Subject: UniStar Nuclear Energy, NRC Docket No. 52-016
Response to Request for Additional Information for the
Calvert Cliffs Nuclear Power Plant, Unit 3,
RAI 345, Vibratory Ground Motion

**Response to NRC Request for Additional Information
RAI No. 345, Question 02.05.02-24, Vibratory Ground Motion
Calvert Cliffs Nuclear Power Plant, Unit 3**

Question 02.05.02-24

FIGURE 1: Comparison of the UHRS obtained from the CCNPP Unit 3 FSAR Rev. 8 and the UHRS obtained with the use of the CEUS SSC model

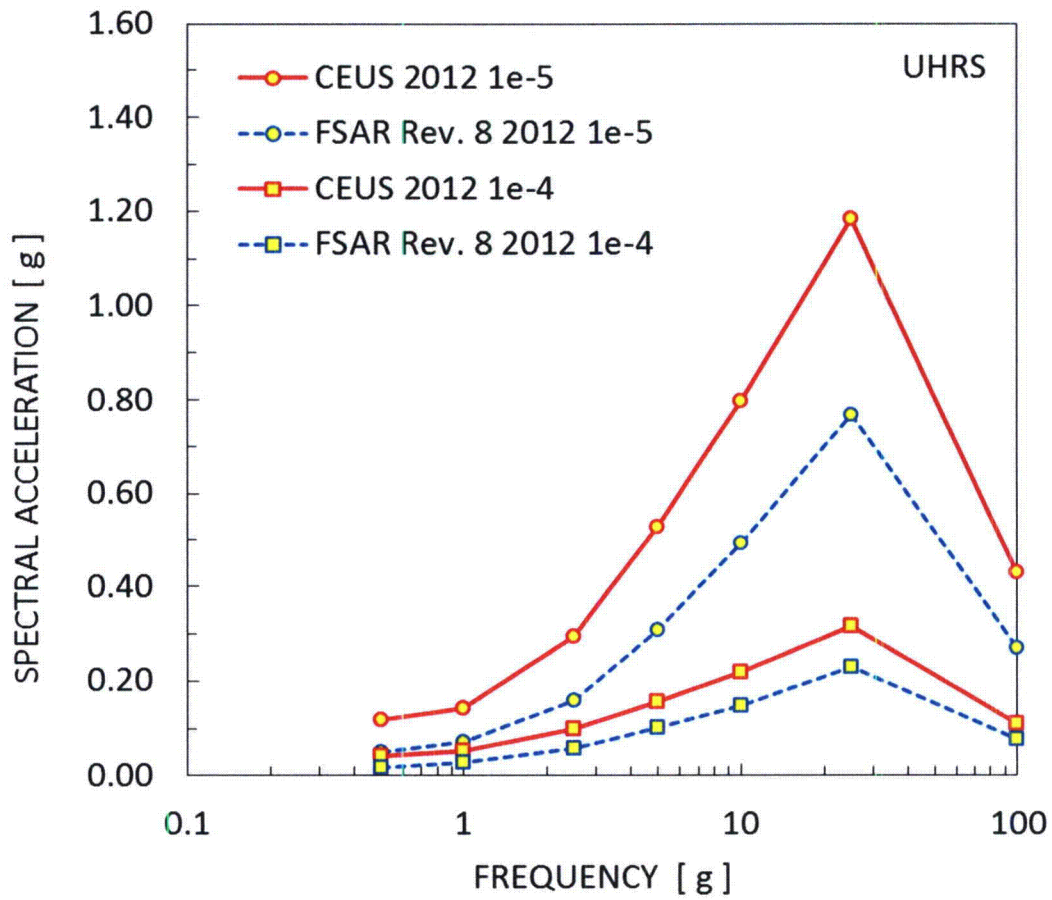
- a) Evaluate the potential impacts of the newly released CEUS-SSC model, with potential local and regional refinements as identified in the CEUS-SSC model, on the seismic hazard curves and the site-specific ground motion response spectra (GMRS)/foundation input response spectra (FIRS). For re-calculation of the PSHA, please follow either the cumulative absolute velocity (CAV) filter or minimum magnitude specifications outlined in Attachment 1 to Seismic Enclosure 1 of the March 12, 2012 letter " Request for information pursuant to Title 10 of the Code of Federal Regulations 50.54(f) regarding Recommendations 2.1, 2.3, and 9.3, of the near-term task force review of insights from the Fukushima Dai-Ichi accident." (ML12053A340).
- b) Modify the site-specific GMRS and FIRS if you determine changes are necessary given the evaluation performed in part a) above.

The impact of the updated CEUS SSC model on the seismic hazard of the CCNPP Unit 3 Site is analyzed by comparing the Uniform Hazard Response Spectra (UHRS) obtained from the previous hazard analysis reported in the CCNPP Unit 3 FSAR Rev. 8, to the UHRS obtained with the new CEUS SSC model. Table 2 and Figure 1 provide the comparison for 10^{-4} and 10^{-5} Mean Annual Frequency of Exceedance (MAFE). For a 10^{-4} MAFE, the UHRS obtained with the use of the updated CEUS SSC presents an increase in the spectral acceleration values of about 40 to about 150 percent. A similar increase of about 55 to about 140 percent is observed for the 10^{-5} MAFE ground motion. The response at the low frequency range is primarily driven by the local source zone that hosts the site and the New Madrid Fault System RLME.
